IEEE P802.1ASdm/D1.0

Rogue Comments related to Figure 17-3

Johannes Specht
(Self)

Source: Figure 17-3 of P802.1ASdm/D1.0

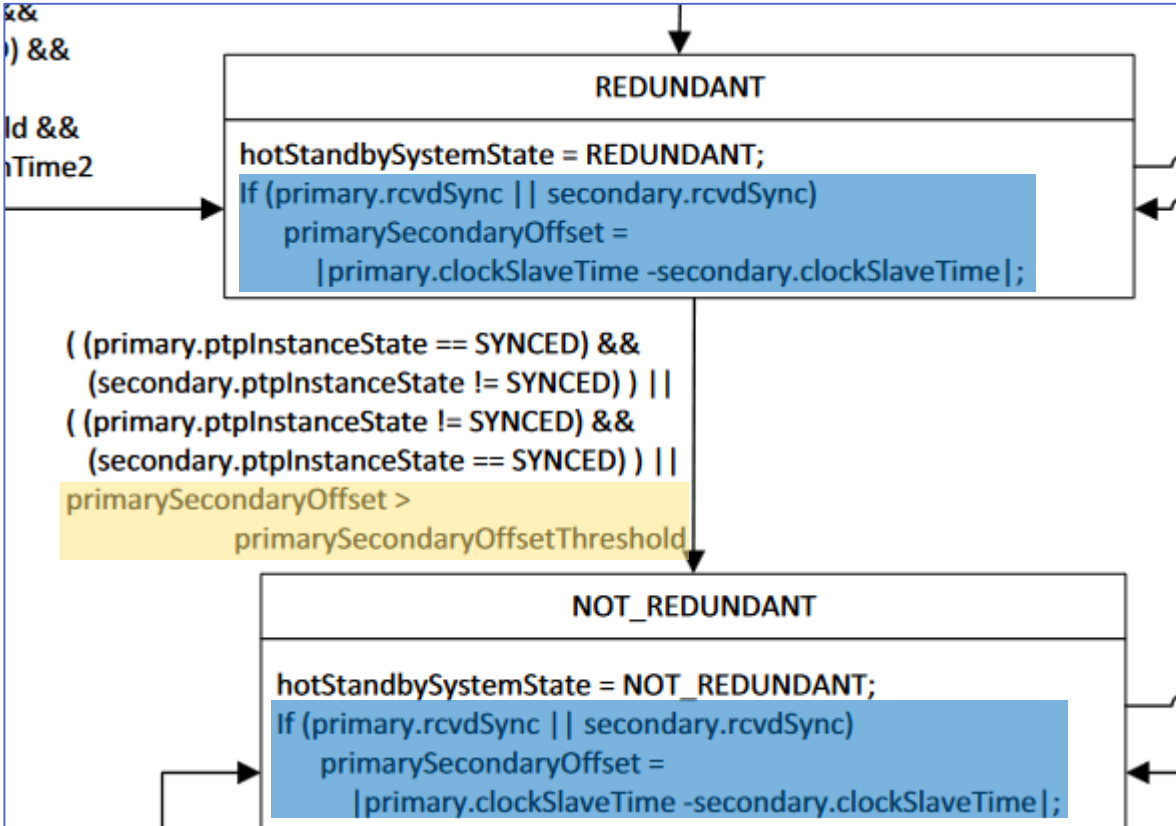
- In Figure 17-3, **primarySecondaryOffset** is **computed only once**, each time a state is entered (blue).
- While the state machine resides in a state, it is **never updated**.
- The associated conditions (yellow “bail-out” in the example) **rarely become effective!**

1. Move primarySecondaryOffset calculations from Figure 17-3 (blue) to a single state in a new state machine, PrimarySecondaryOffsetCalculation.
2. Cause a self-transition of that new state whenever updateSlaveTime() is invoked, potentially additional events.
3. Keep the the offset-OK condition (yellow) where they are.

Source: Figure 17-3 of P802.1ASdm/D1.0

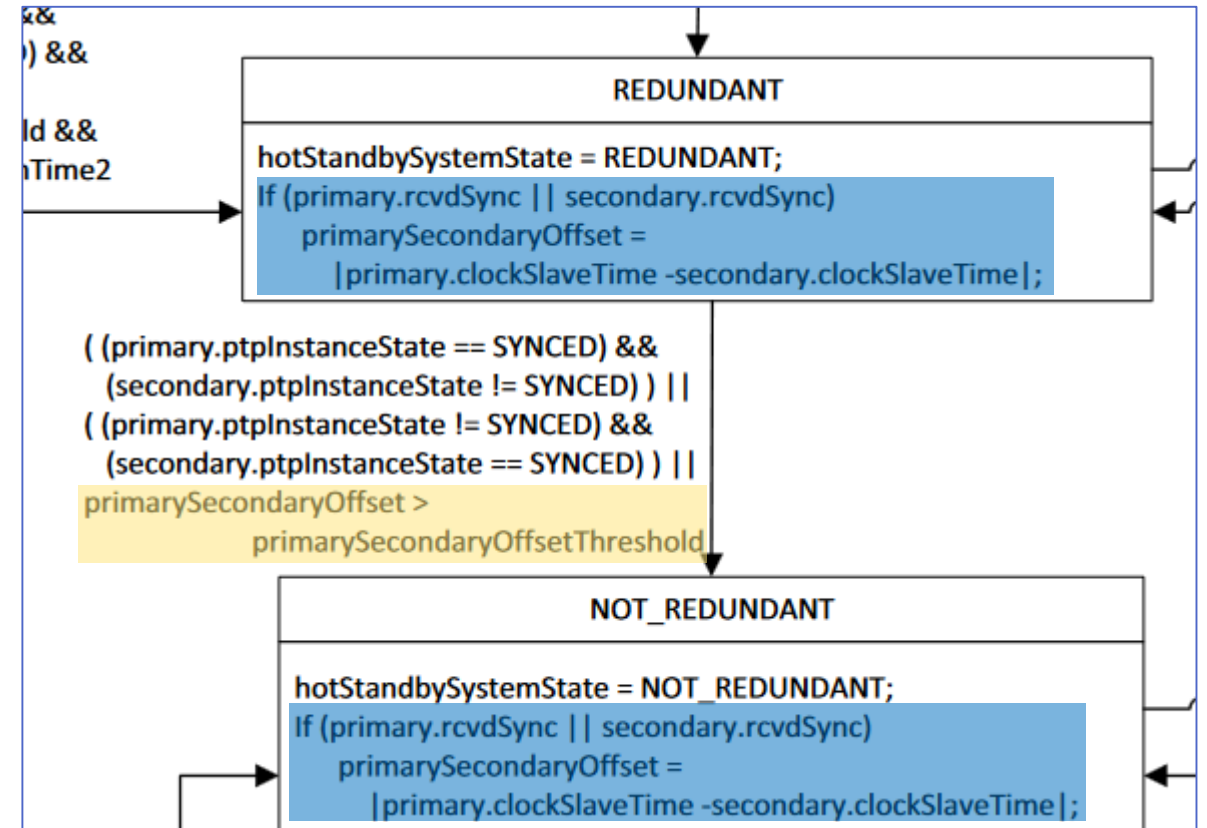
- ... even if the conditional update (blue) would be executed on more frequently (which it doesn't, as shown earlier), the condition (if-expression in blue) would not work reliable.
- Primary/secondary.rcvdSync is rarely TRUE and most of the time FALSE, because it is a synchronization variable consumed and reset by another state machine, resulting in a race condition.
- Next slide ...

Source: Figure 11-6 of P802.1ASdm/D1.0, MDSyncReceiveSM

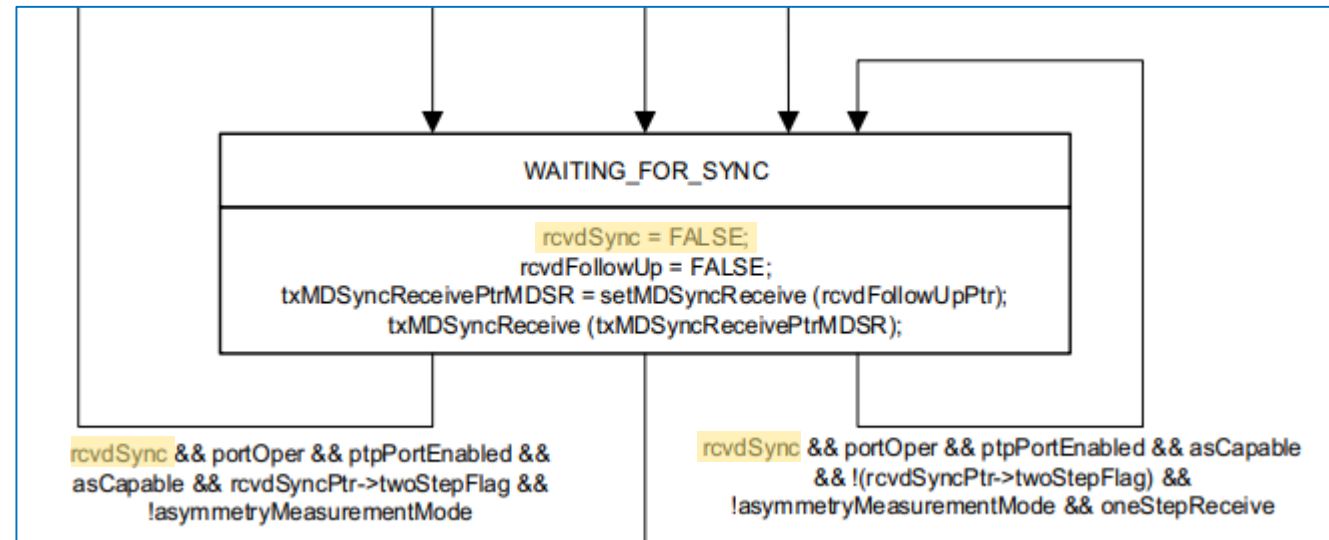
- Once `rcvdSync==TRUE` and causes a transition in `MDSyncReceiveSM`, it is **set to FALSE immediately by `MDSyncReceiveSM`** in most cases (not only the example shown).
- The Figure 17-3 FSM may miss `rcvdSync==TRUE`.

- Setting `rcvdSync` to `TRUE` is unspecified in Std 802.1AS-2020.
- The statement in 11.2.14.1.2 may be enhanced (i.e., “sub-sub-issue”).

Source: Figure 17-3 of P802.1ASdm/D1.0

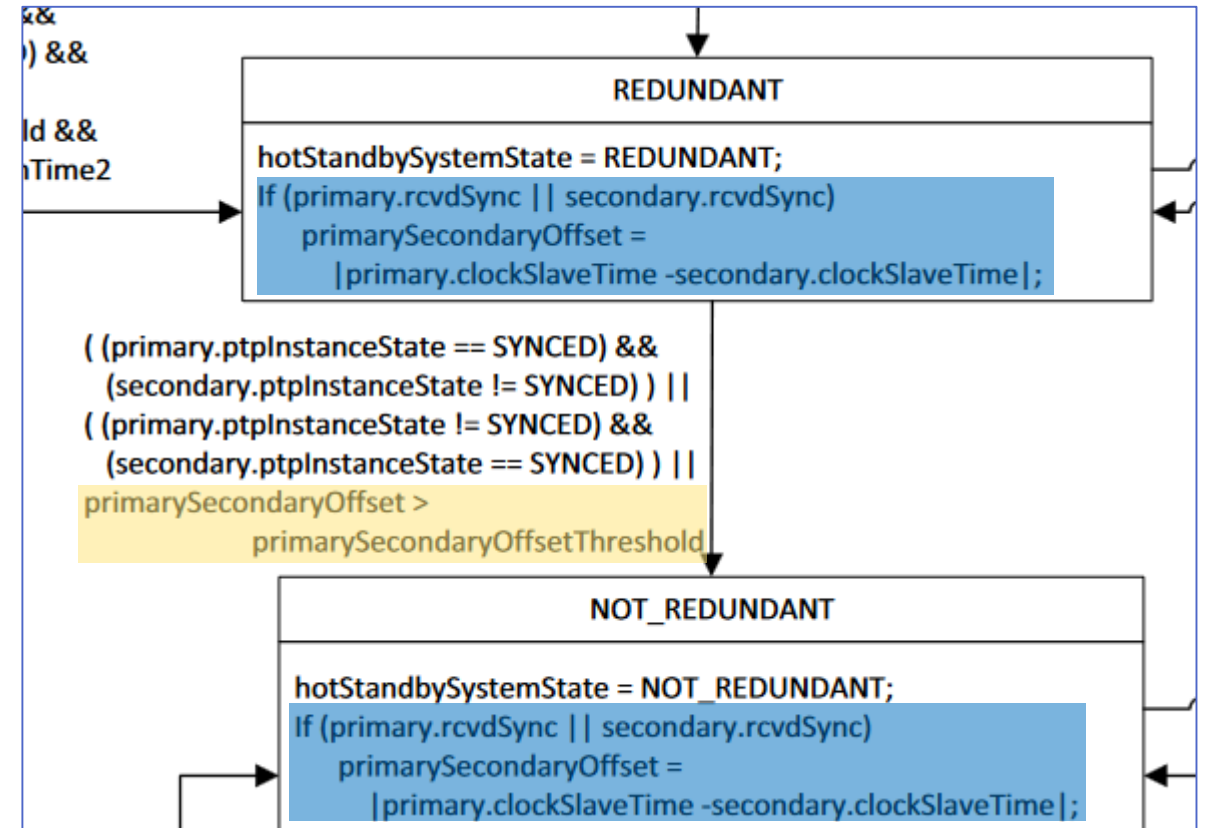
- ... even if the update (blue) would be executed on every sync message (which it doesn't, as shown earlier), the given update frequency on `rcvdSync` (i.e., on sync message reception) would be too low.
- The offset between the underlying variables, `clockSlaveTime` in 10.2.4.3, can become larger between such messages.
- Next slide ...

→ Update **every LocalClock tick** required (**not** just every sync message)...

Figure 10-4—PortSyncSyncReceive state machine

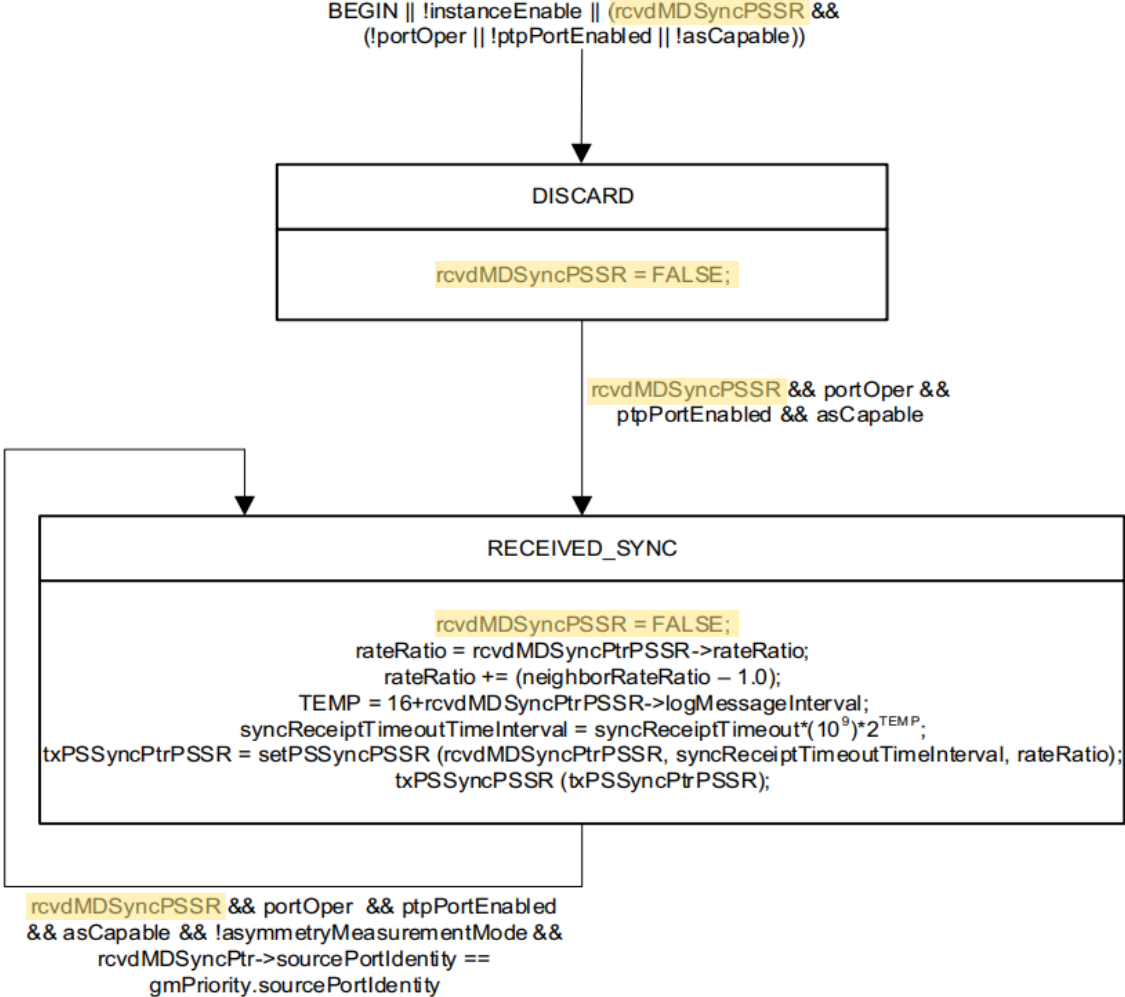
- ...,well, it does not expose the **rcvdSync** variable, but instead exposes **rcvdMDSyncPSSR** with name **rcvdSync**, where **rcvdMDSyncPSSR** is consumed by media-independent state machine PortSyncSyncReceive:
 - **Alias** 😞
 - **Ambiguity** 😞

- Like the **rcvdSync** variable, the **rcvdMDSyncPSSR** variable is immediately reset to FALSE by PortSyncSyncReceive in most cases (next slide).
- The value of exposing **rcvdMDSyncPSSR** seems low:
 - Reading/polling it (e.g., via NETCONF) returns “FALSE”, “TRUE” seems like a glitch.
 - But if it is there, it needs to be tested 😞

1. Remove 14.8.7 (i.e., rcvdSync Management Variable) from P802.1ASdm.
2. Potentially use rcvdMDSyncPSSR (media independent) instead of rcvdSync (media dependent) in the new suggested state machine from issue #1 in this slide set.
